Agenda
Hearing Examiner Meeting
Monday, June 20, 2022
Richland City Hall ~ Council Chambers
625 Swift Boulevard
[Zoom](#) – Public Telephone Access: (206) 337-9723 or (253) 215-8782
Meeting ID No. 872 2126 7401

PUD2021-102 Skyhous

**CITY OF RICHLAND DEVELOPMENT SERVICES DIVISION
STAFF REPORT TO THE HEARING EXAMINER**

PROPOSAL NAME: Skyhous – Planned Unit Development

Figure 3 - Utilities Map
(Blue = water, Green = sewer, Red = electrical power)

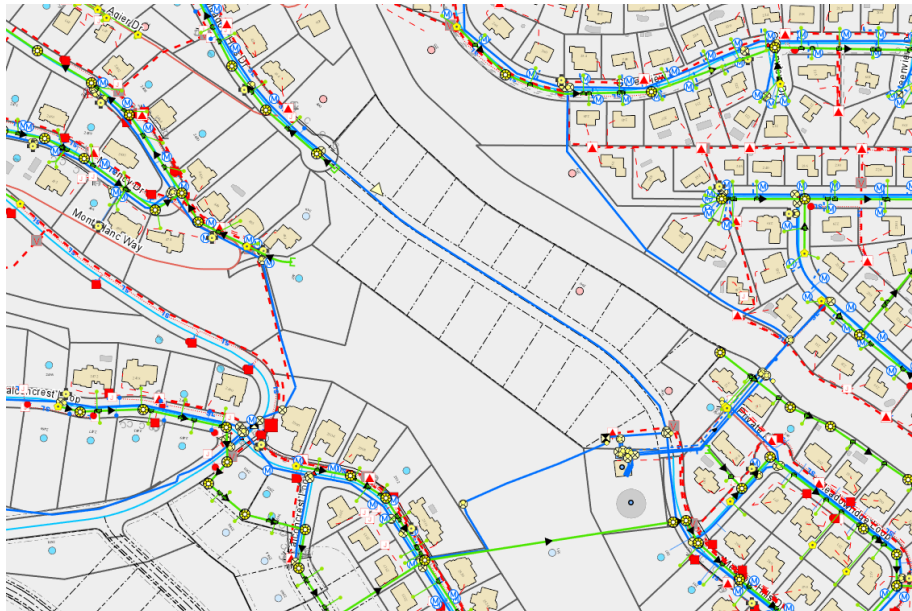
City utility mapping records indicate underground utility infrastructure as illustrated in Figure 3 provided below. Written explanations of each utility service are provided in the following sections.

There is a 12-inch water main that bisects the property in the location of the proposed Meadow Hills Drive extension. Adequate water supply exists to provide potable water to the site.

Figure 1. WDFW PHS Mapping Tool shows Shrubsteppe PHS (outlined in aqua) on project site (outlined in red). The purple indicates other priority habitat areas.¹⁰

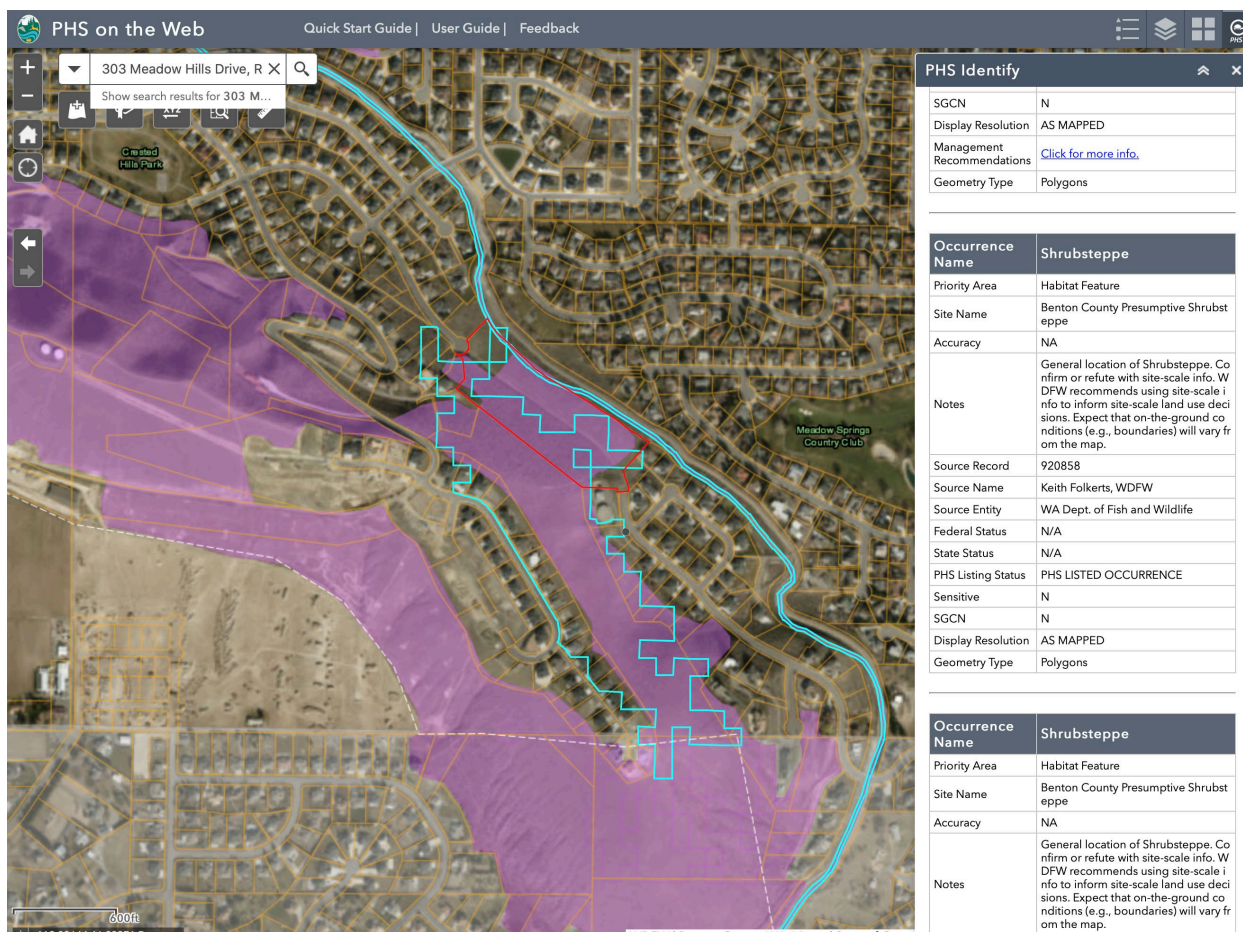
The proposal maintains lower quality habitat in the more northern, lower portion of the site as natural open space; however the high quality shrubsteppe habitat on the southern portion of the lot will be totally removed ([Figure 1](#)). The proposal also fragments a viable wildlife corridor that is a link situated between large tracts of priority habitat.
